- a. Request for Comments – 3rd Request (planning engineering only)
- b. Technically Complete Letter with all agency comments and conditions.
 - i. Melissa Owen – City of Spokane Planning Comments
 - ii. Joellie Eliason – City of Spokane Engineering Comments
- c. Applicant Response to Request for More Information (RFC no. 2)

Exhibit 11 - RFC No. 3: 1.a.Request for Comments – 3rd Request

Latah Glen Residential Preliminary Long Plat

FILE NO. Z25-371PPLT

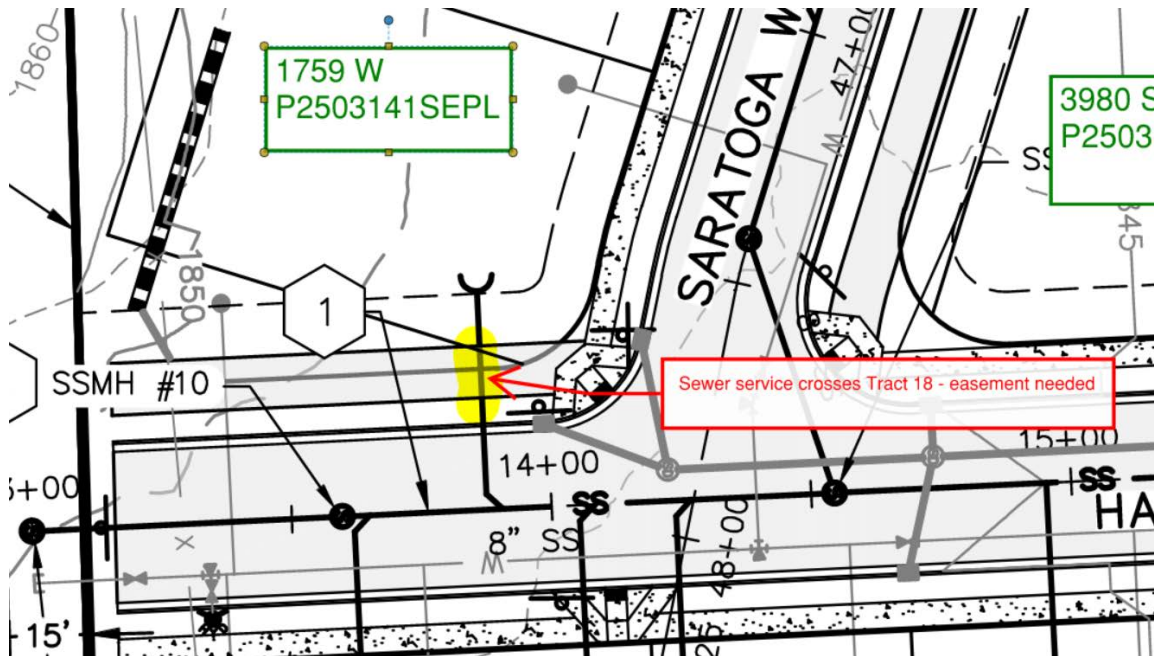
2. A sewer easement will be required for the proposed sewer connection to Lot 3 Block 16 (see snip below from construction plans).

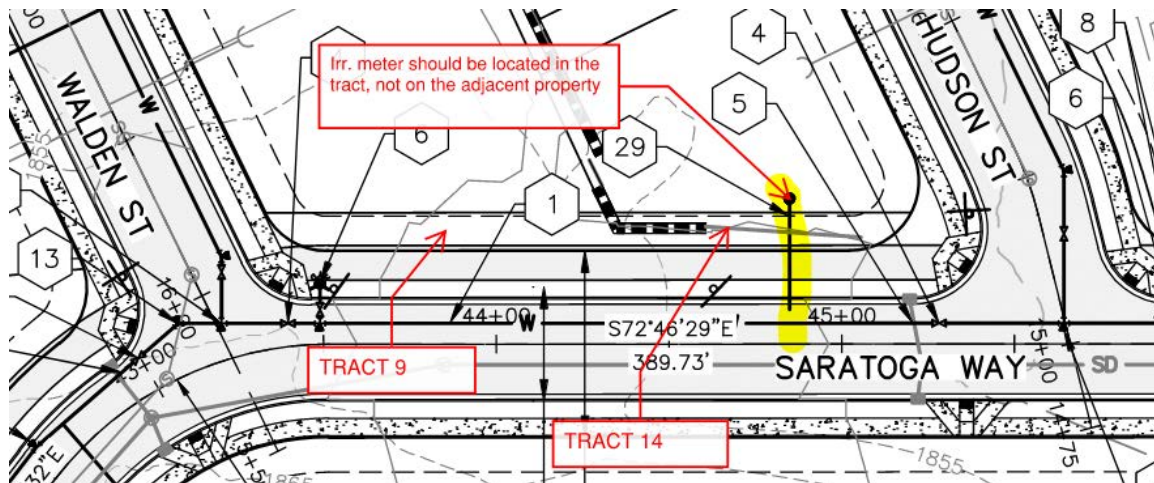
3. Is it intended for Tract 9 and Tract 14 to share an irrigation meter (see snip below)?

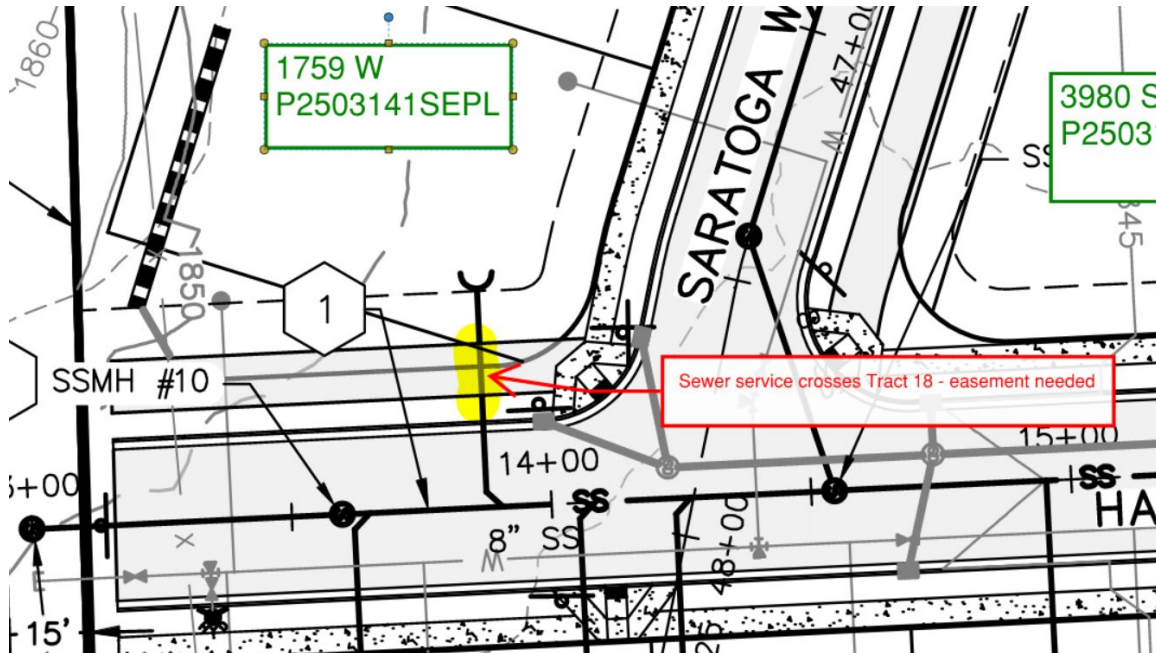
2. A sewer easement will be required for the proposed sewer connection to Lot 3 Block 16 (see snip below from construction plans).

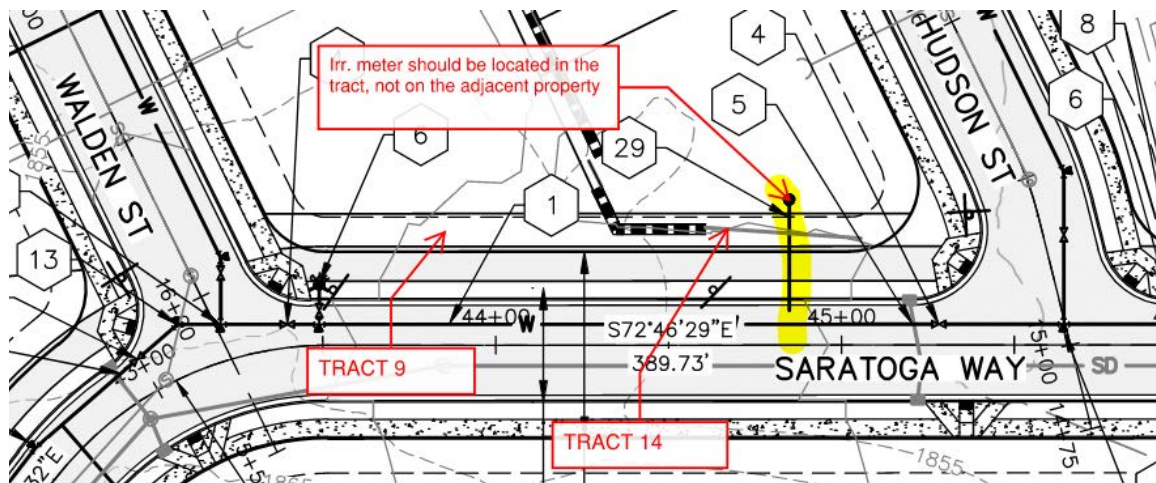
3. Is it intended for Tract 9 and Tract 14 to share an irrigation meter (see snip below)?

From sewer drawing.

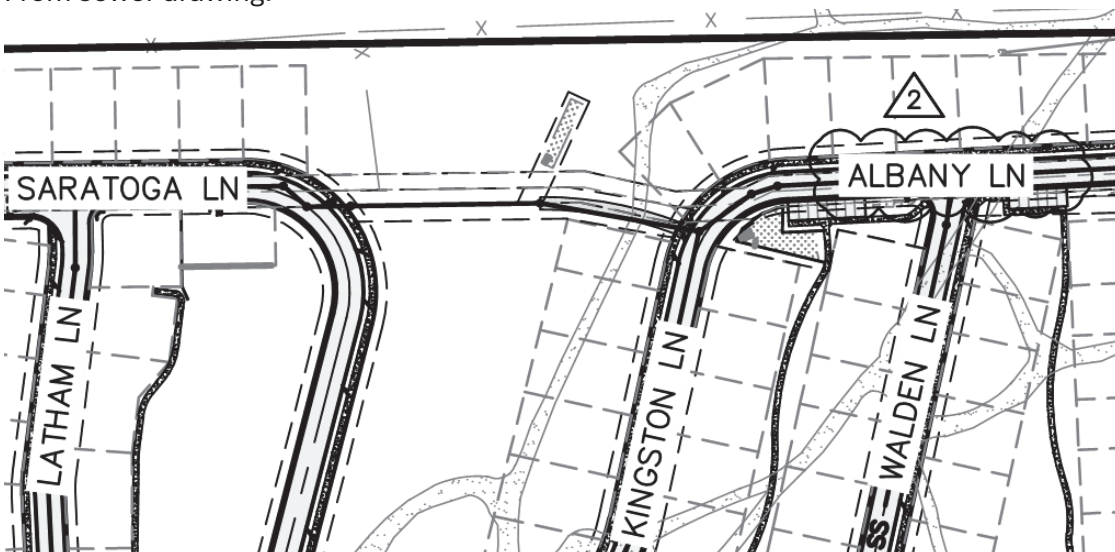
It appears they have left off the utility easement for both water and sewer in parallel from Saratoga to Albany. Easement will need to be 30' wide, not 16' wide, and should be within a utility tract for boundary definition.

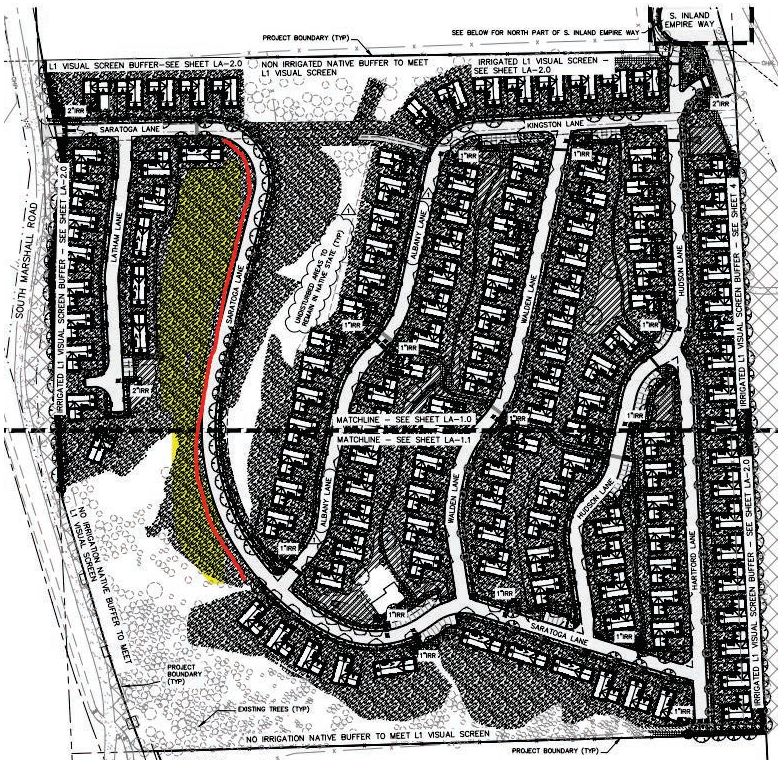
There is a section of the proposal where street trees behind the curb may not be a good idea – the slopes and stormwater requirements would be a challenge to maintaining trees in good health and may impact the stormwater solution being constructed. See the image below for the area of concern.

From sewer drawing.

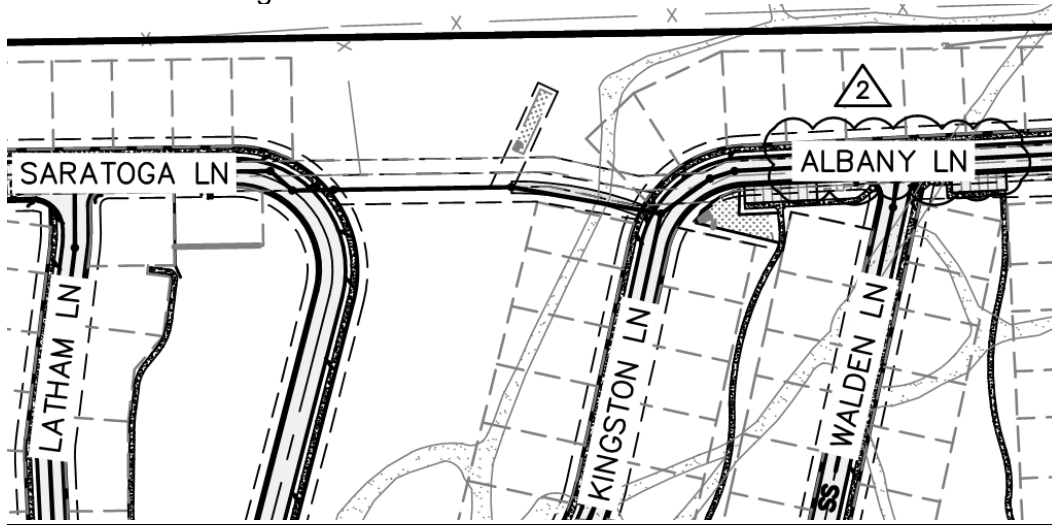
- A. It appears they have left off the utility easement for both water and sewer in parallel from Saratoga to Albany. Easement will need to be 30' wide, not 16' wide, and should be within a utility tract for boundary definition. (M. Owen Note: A new separate easement will need to be recorded and documented on the plat map prior to final plat approval per M. Owen Conversations with Eldon Brown.)

From sewer drawing.

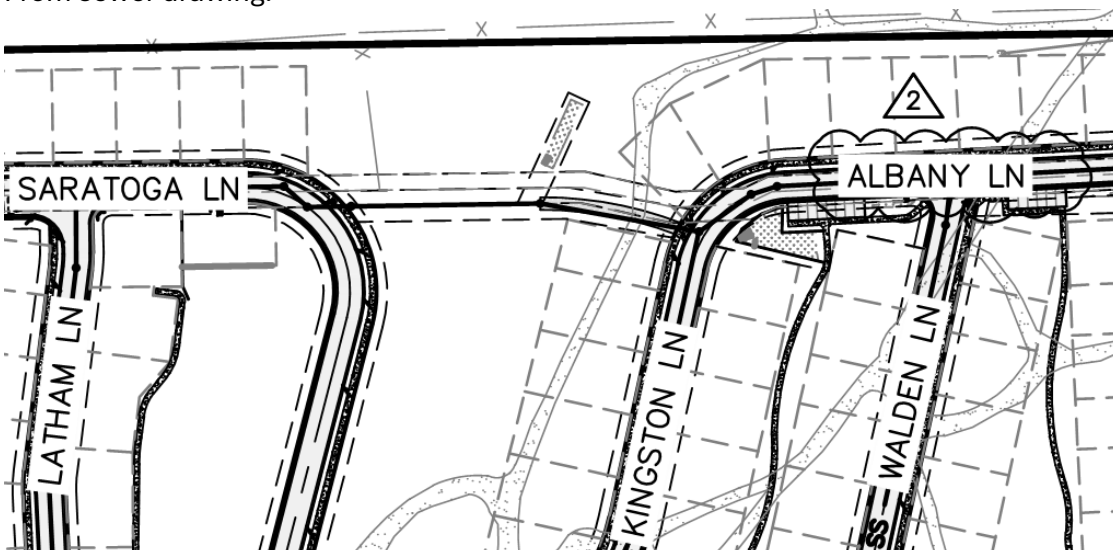
It appears they have left off the utility easement for both water and sewer in parallel from Saratoga to Albany. Easement will need to be 30' wide, not 16' wide, and should be within a utility tract for boundary definition.
